Re: Interpretation for RZ 87-V-092, 108-1 ((1)) 22A, 8824-SP-01, Telegraph Road
Property, Proffer Number 9, Stormwater Management

Re: Rezoning RZ 87-V-092 9040 Telegraph Road
Tax Map Ref: 108-1 ((1)) 22A Site Area: 1.86 Acres
Site Plan Number 8824-SP-01 Zoning District C-6
Project Name: Telegraph Road Property
REQUEST FOR PROFFER INTERPRETATION

Re: Interpretation for RZ 91-V-003, Pohick Landing, Proffer, Number C.3.

POHICK LANDING
Traffic Noise Analysis

PRELIMINARY PLAT

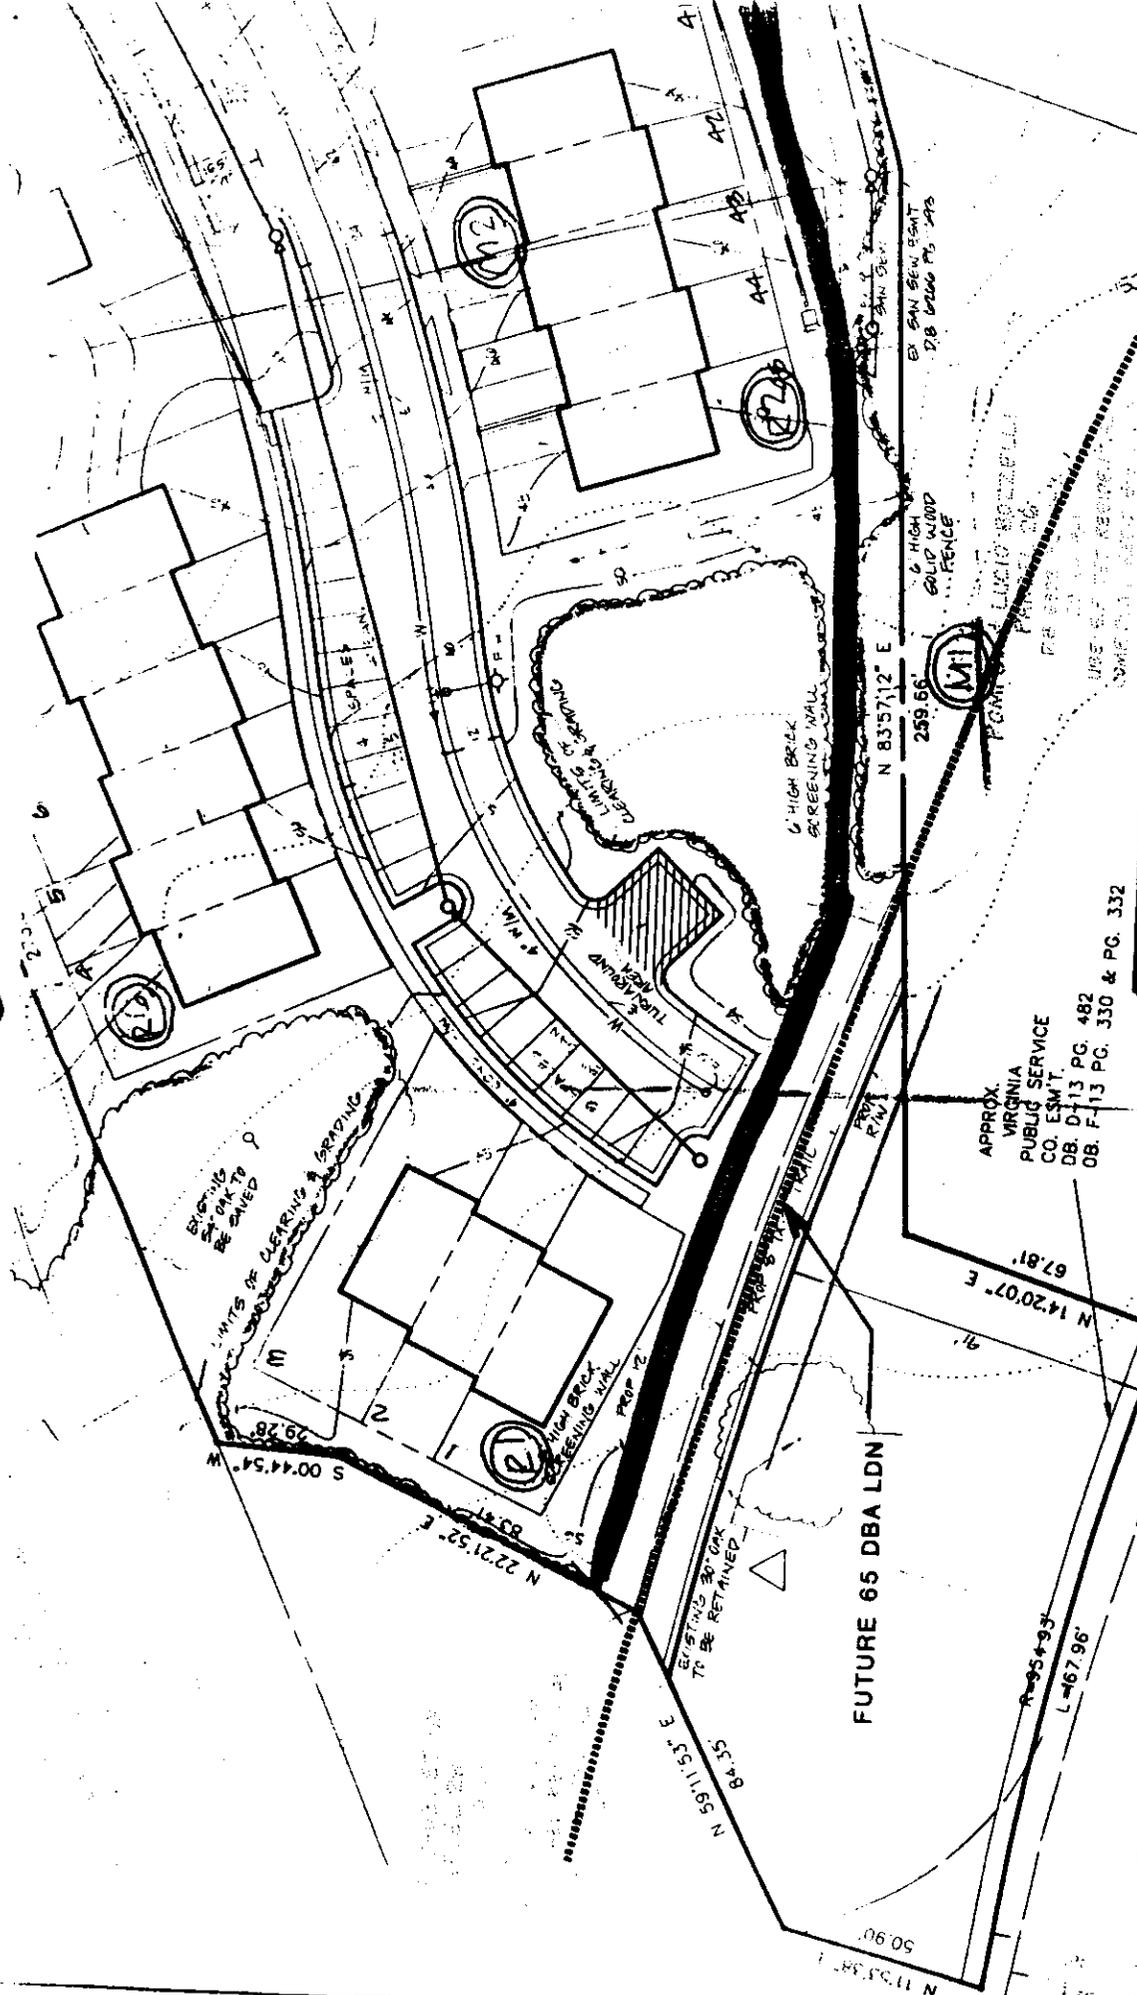
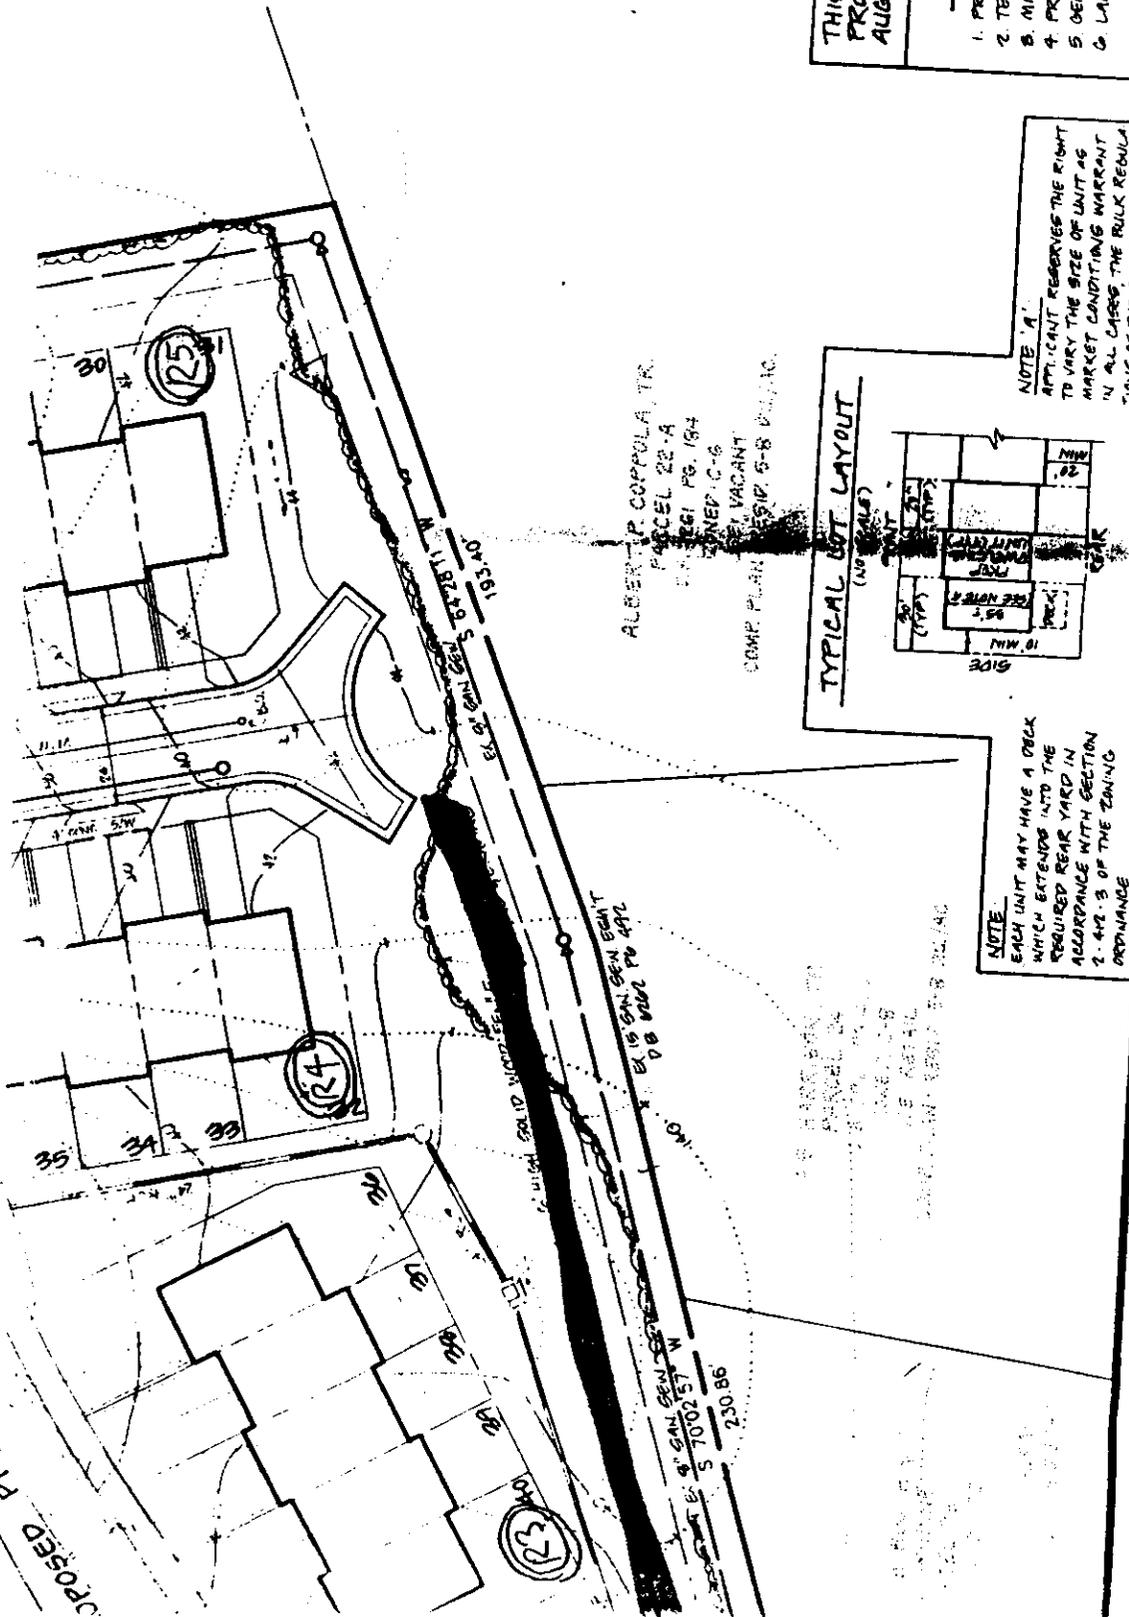
The forecasted noise levels in the rear yards of all proposed units are within the 65 dBA noise contour drawn on the attached site plan. Noise levels in rear yards will be in the range of 59 - 63 dBA Ldn for the first row of houses (see the attached STAMINA output). As previously mentioned, noise levels in the yards of the second row of houses and in yards partially or fully shielded by the first row of houses will be lower.

The designs for the proposed Pohick Landing project shown on the Urban Engineering Preliminary Plat dated October, 1992, will meet Fairfax County acoustical requirements.

These requirements will be met based upon the Urban Engineering Preliminary Plat dated October, 1992. The noise wall shown on the plan is not necessary to meet the county requirements nor are any other noise attenuation measures.
